APPLICATION NO.	FILING DATE	FIRST NAMED INVENTOR	ATTORNEY DOCKET NO.	CONFIRMATION NO.
10/566,455	01/30/2006	Shriram Shivanand Pathak	19365103945	5578
7590	07/14/2008		EXAMINER	
Robin W Asher Clark Hill Suite 3500 500 Woodward Avenue Detroit, MI 48226-3435			WUJCIAK, ALFRED J	
			ART UNIT	PAPER NUMBER
			3632	
			MAIL DATE	DELIVERY MODE
			07/14/2008	PAPER

<b>Office Action Summary</b>	<b>Application No.</b>	<b>Applicant(s)</b>	
	10/566,455	PATHAK ET AL.	
	<b>Examiner</b>	<b>Art Unit</b>	
	Alfred Joseph Wujciak III	3632

This is the final Office Action for the serial number 10/566,455, VEHICLE SEAT ASSEMBLY AND FLOOR RAIL FOR LATERAL SEAT SHUTTING, filed on 1/30/06.

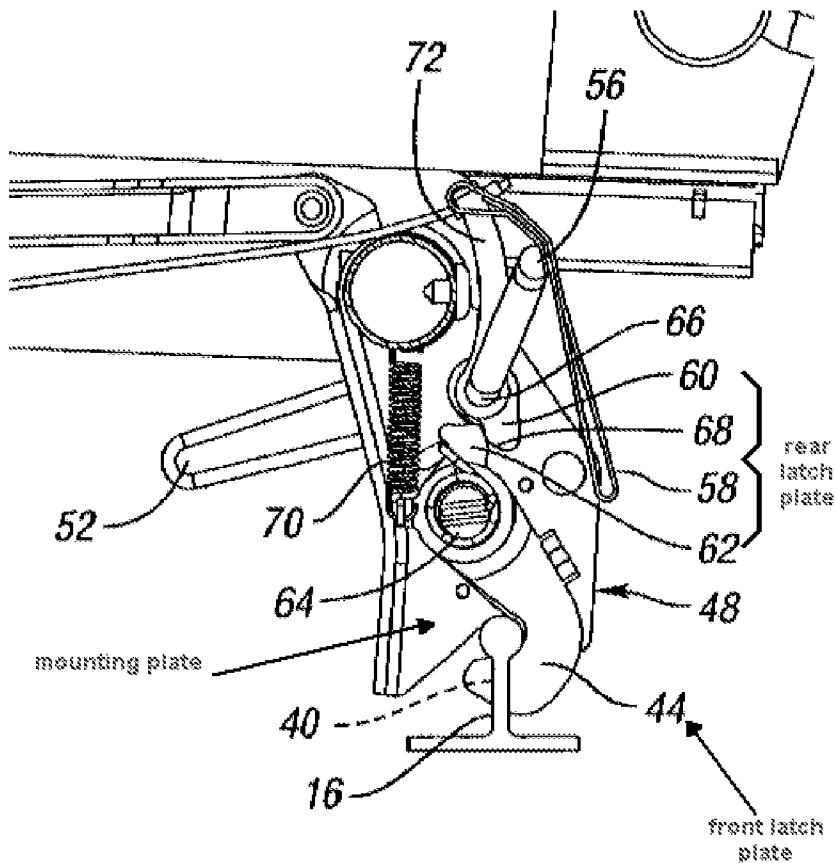
Milnar et al. teaches an assembly comprising a front latch mechanism (50) having a support plate (22) and a rear latch mechanism (48) having a mounting plate (figure 5, see diagram below). The rear latch mechanism includes a pair of front (44) and rear (60, 62) latch plates. The assembly includes a release cam member (52) operatively coupled between the front and rear latch plates. The front latch mechanism includes a latch plate (46) to the support plate. The assembly further comprises a connecting link (74) extending between the release cam member and the latch plate.

Since the applicant amended claim 1 which requires the examiner to change the reference numbers in the office action, Milnar et al. now teaches the front and rear latch plates are independently pivotally coupled to the mounting plate (see the diagram above in this office action for clarification). Furthermore, the release cam member of Milnar et al. engages the rear latch plate which also engages the front latch plate in order to release from the rail.
